Origination Form
Proposed Revisions to a Standard Plans Index

Originator:	Meyer, Ronald and Lemus, Vivian	Index Number:	700-120
Date:	6/22/2026	Sheet Number(s):	1,2,5,6,7
E-mail:	Ronald.Meyer@dot.state.fl.us	Index Title:	ENHANCED HIGHWAY SIGNING ASSEMBLIES

DETAIL "A"

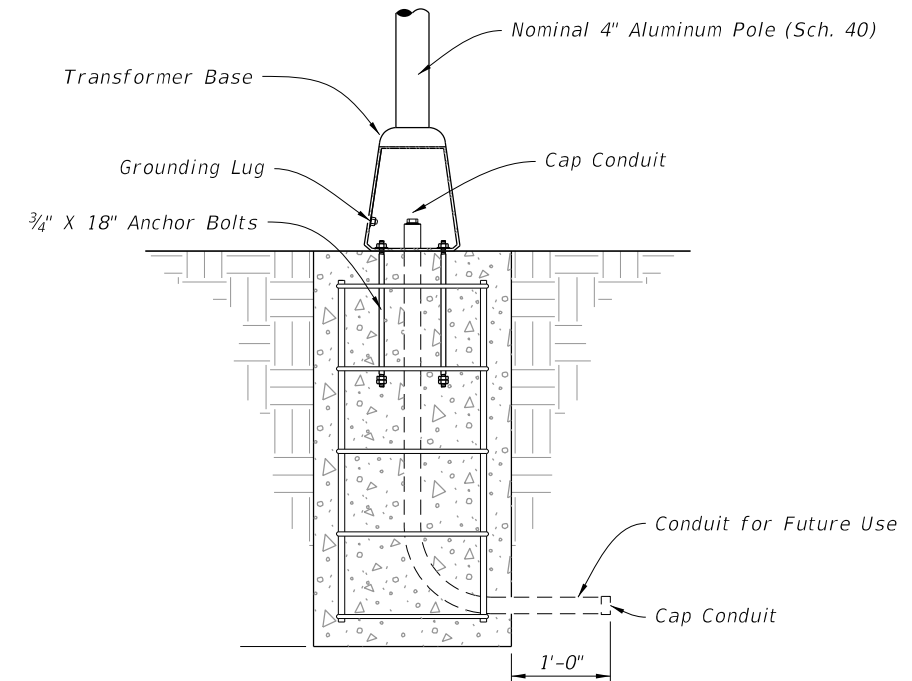
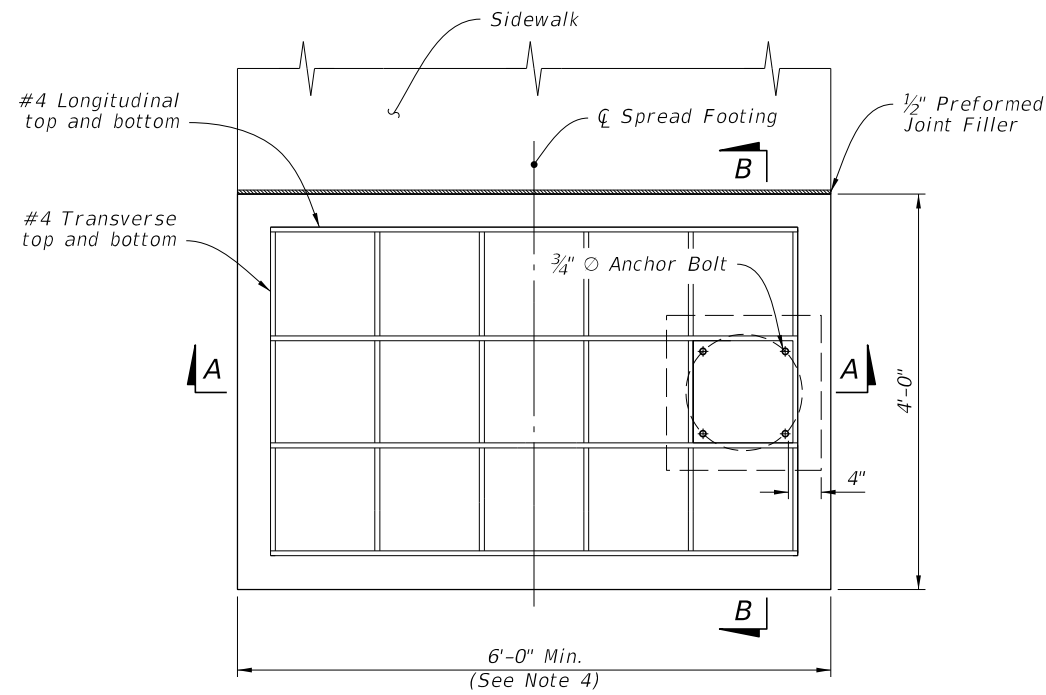
Sheet 2: Updated electrical component in Detail "A"

Sheet 2 - To improve the electrical safety and operational reliability of Enhanced Highway Signing Assemblies. The change reduces the likelihood of energized conductors being exposed after a knockdown event, minimizes equipment damage, and enhances overall system safety.

LAST REVISION		DESCRIPTION:		FDOT		FY 2026-27 STANDARD PLANS		ENHANCED HIGHWAY SIGNING ASSEMBLIES		INDEX	SHEET
11/01/25		11/01/26								700-120	5 of 13

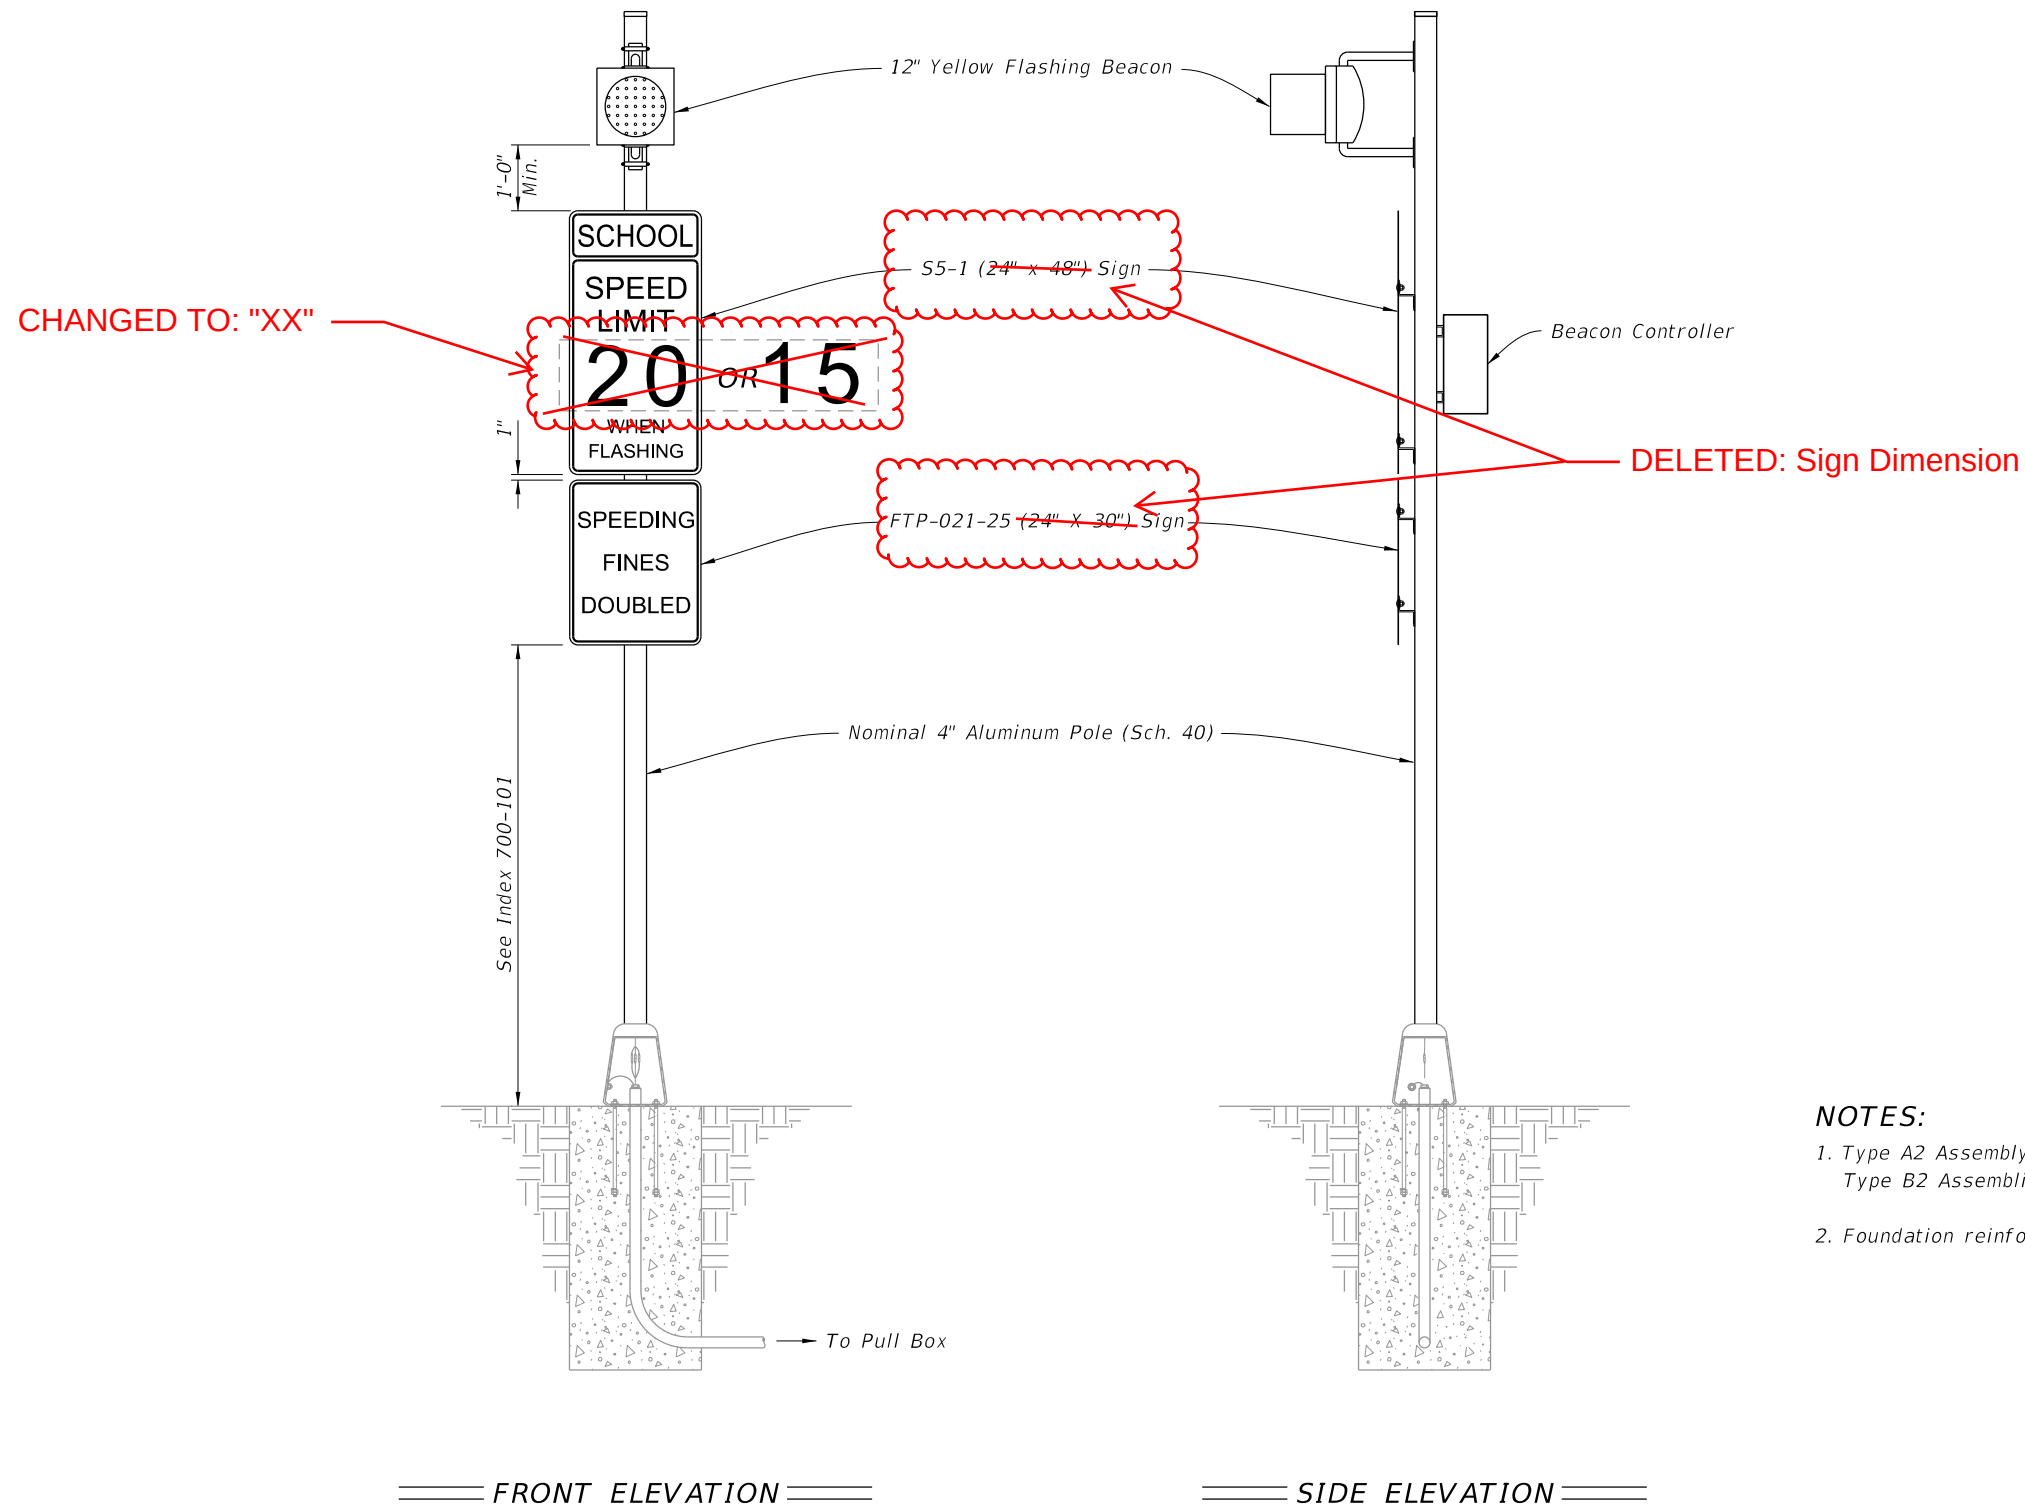
Sheet 5: Deleted dimensions for S5-1 and FTP-021-25; Changed the speed limits from "20 or 15" to "XX" to match figures in upcoming release of Speed Zoning Manual.

Sheet 5 - should be updated to remove specific dimensions for S5-1 and FTP-021-25 and clarify that speed limits can be other than 20 or 15 as appropriate (recommend changing to "XX" to match figures in upcoming release of Speed Zoning Manual); Added Callout & S4-3P Sign.

DELETED SHEET 6

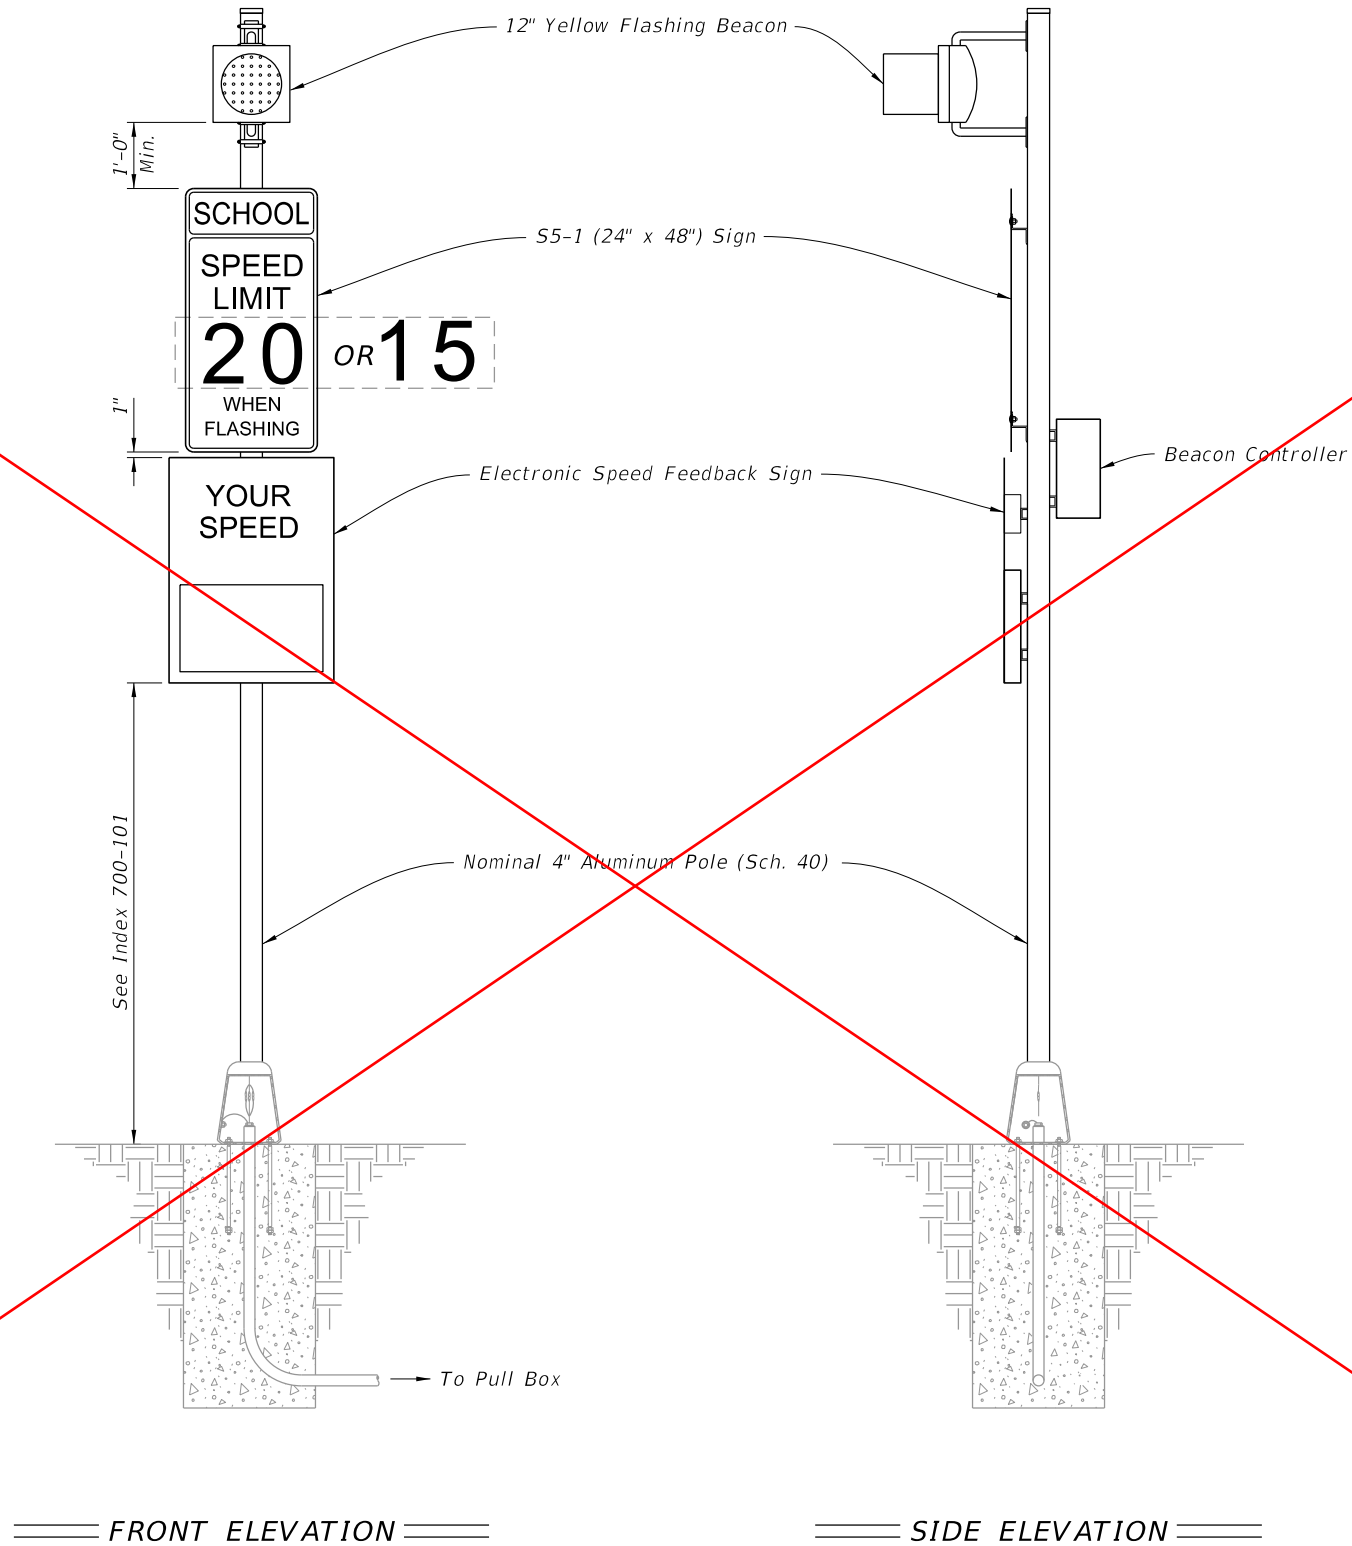
Sheet 6: Deleted Sheet - MUTCD guidance has changed regarding use of speed feedback devices.

Sheet 6 - must be deleted because MUTCD guidance has changed regarding use of speed feedback devices. In addition, due to statutory requirements to include a "SPEEDING FINES DOUBLED" plaque (FTP-021-25), there cannot also be a speed feedback device on the assembly. School zone signs with flashing beacons must comply with 700-120, Sheet 5 (i.e., FTP-021-25 mounted directly below the school zone speed limit sign).

ROADSIDE SIGN ASSEMBLY-5

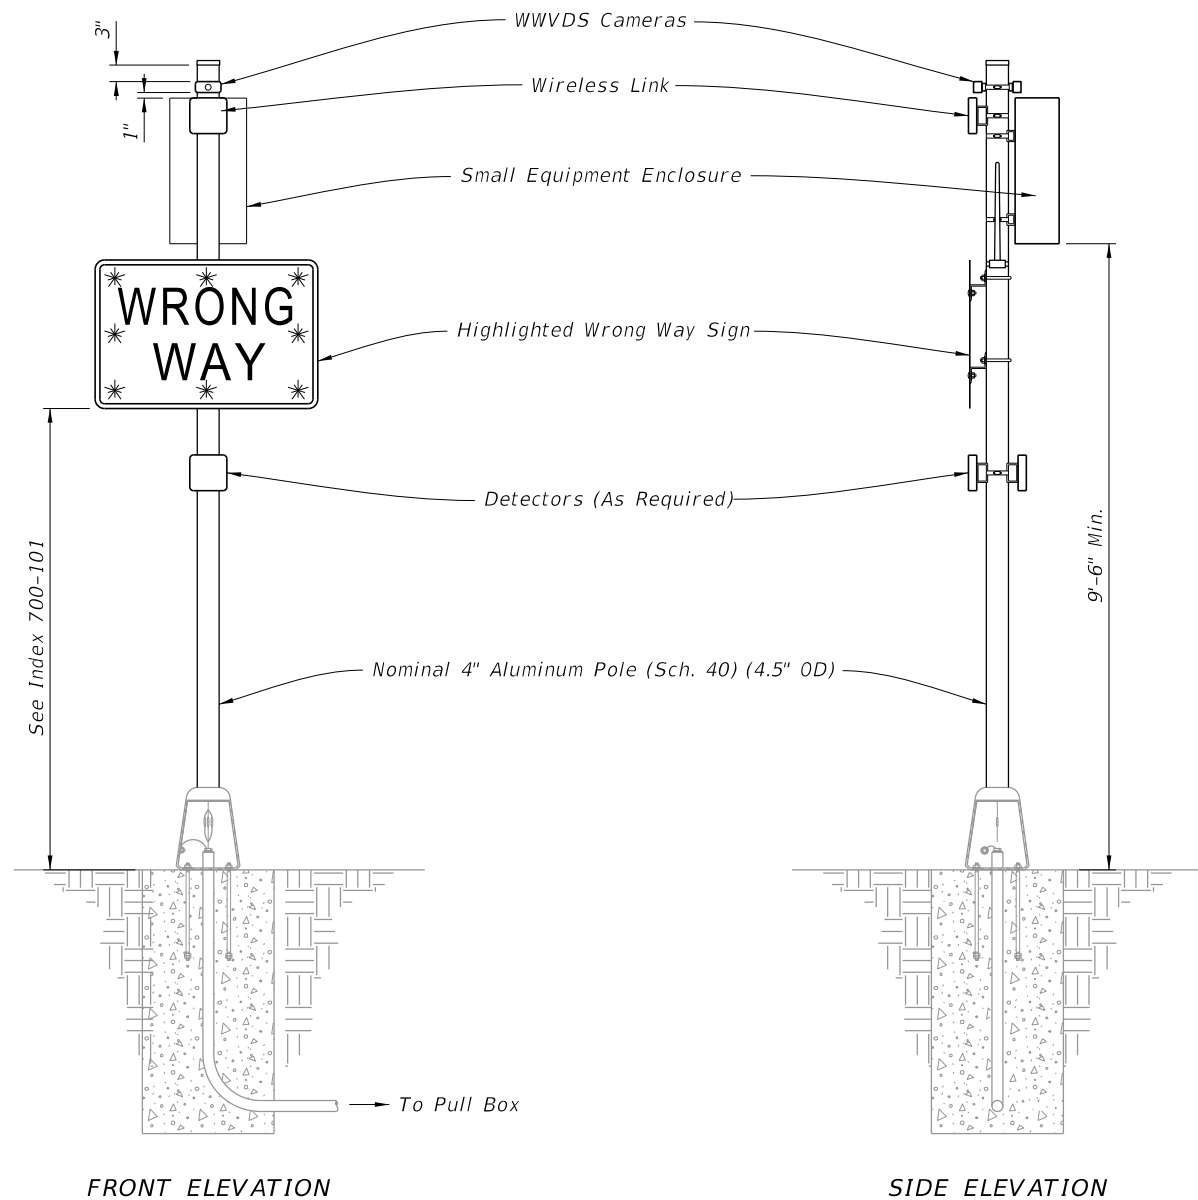
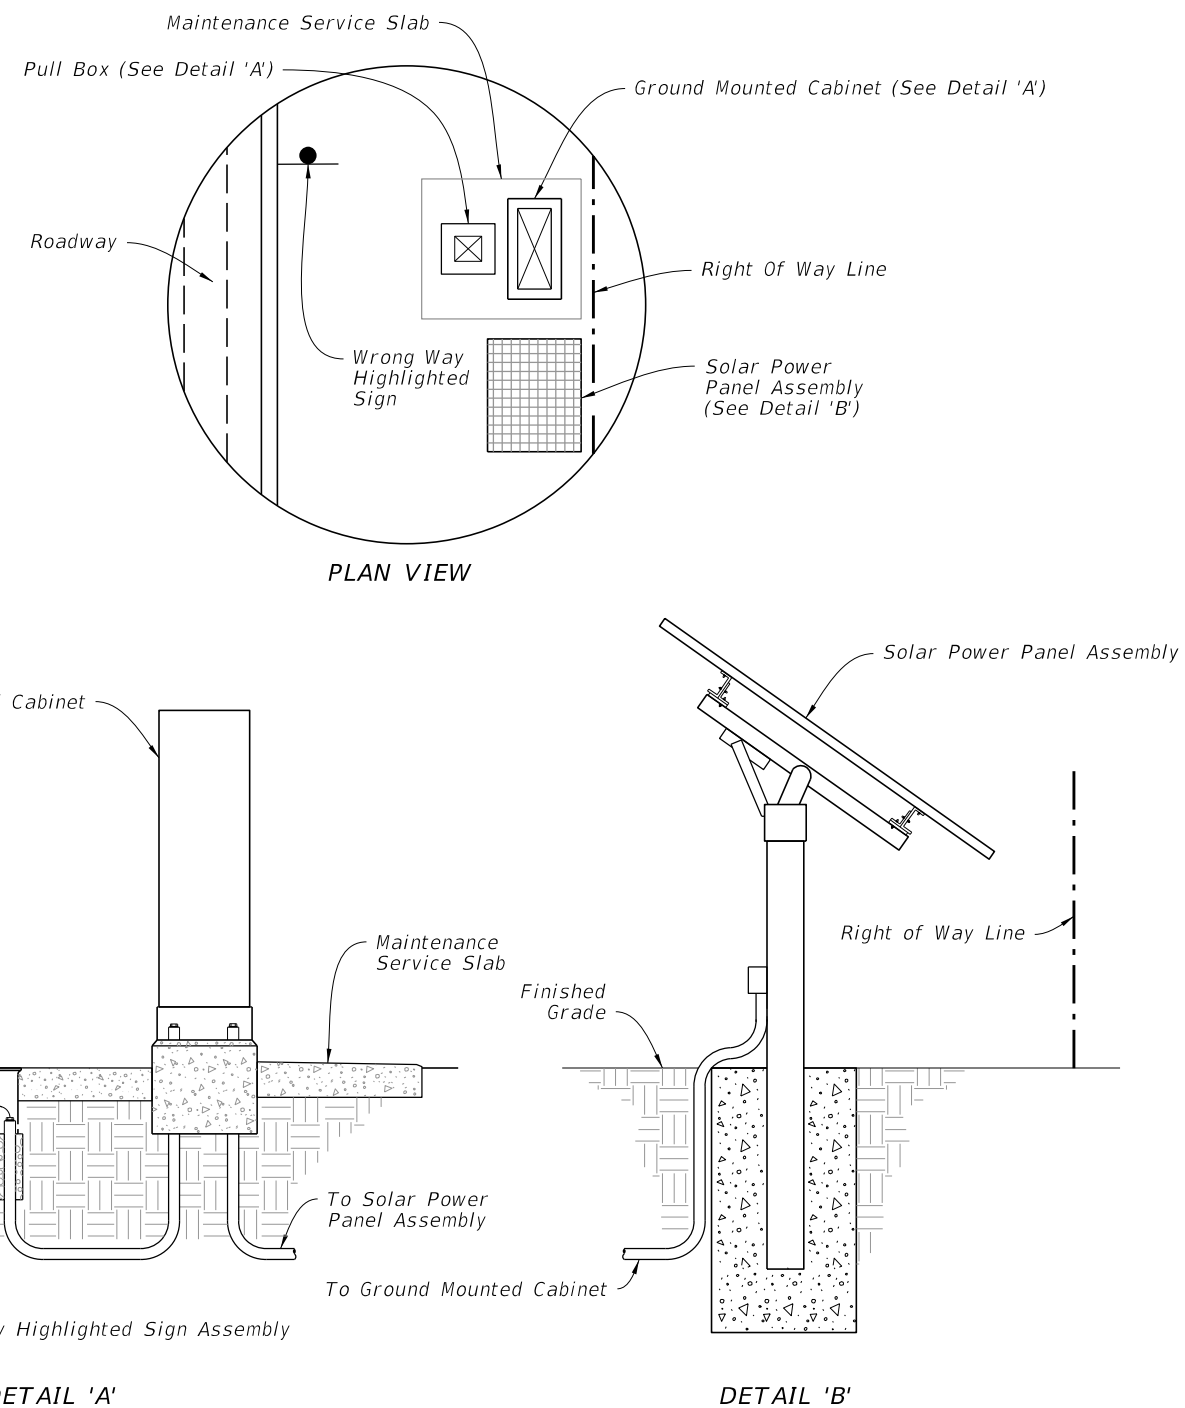
Sheet 7 (New Sheet 6): Added "(Per Plans) to the 12" Yellow Flashing Beacon callout; Deleted dimensions for R2-1; Updated the "Electronic Speed Feedback Sign" to "W13-20aP Vehicle Speed Feedback Plaque; Updated the "Your Speed" sign to match the shape and size of the W13-20aP Vehicle Speed Feedback plaque as required and shown in the latest MUTCD; Deleted Note 2

Sheet 7 - (New Sheet 6) must be updated to better match the shape and size of the W13-20aP plaque as required and shown in the latest MUTCD. The TERL has been in contact with speed feedback sign vendors listed on the APL regarding both standalone signs and plaques. Vendors are aware of the MUTCD changes and their need to comply with MUTCD requirements to have products listed on the APL. Note 2 - reflect the reference to SHS and MUTCD
